**From:** [REDACTED]  
**To:** [A303 Stonehenge](#)  
**Cc:** [REDACTED]  
**Subject:** A303 Stonehenge (TR010025) - Wiltshire Council Deadline 4 Submission  
**Date:** 21 June 2019 22:37:01  
**Attachments:** [REDACTED]

**Re: A303 Amesbury to Berwick Down (TR010025) – Wiltshire Council Response to  
Deadline 4**

**Wiltshire Council (A303-AFP022)  
Review of Updated Outline  
Environmental Management Plan  
(OEMP) (001011) Submitted at  
Deadline 3**

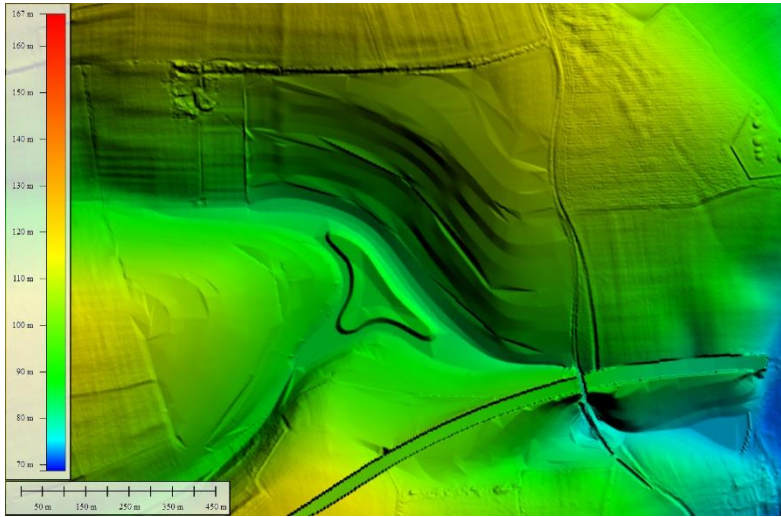
1B Fig 4.5	The baseline worst case flood extent/depth (6 hours) has not been compared to a longer storm duration scheme event (12 hours) to ensure any other risks are recognised. The culverts that are proposed may constrict flow (especially if groundwater also partially fills these) and therefore cause ponding of water. Given the longer storm duration is shown to have a larger volume (Table 4.2) the results shown do not confirm if the scheme has considered the worst-case scenario for both scenarios. To ensure that the performance of

Section	Discussion
	the scheme is fully understood, the results of multiple duration scheme models is required to be tested and discussed.
1B 4.4	POINT 4 from the findings of the previous review on the opening page of this document are addressed in part in this section of the report however a comparison of worst case for both scenarios has not been undertaken (which is requested in 1B Fig 4.5 and conclusion).
1B 4.4.3	Would flood depths be greater if the 12 hour duration scheme model results were compared to the worst case 6 hour baseline event given the statement that the proposed scheme has a substantial impact upon flow. The analysis discussed is based on a like for like duration (which is acceptable) however it would be pertinent to determine the difference in maximum risk of both scenarios. It is envisaged that if the results for a longer duration show a greater depth/extent, it would still be within the Highways England land jurisdiction and therefore acceptable, however, it must be ensured that the worst case is presented to ensure all risks are identified.
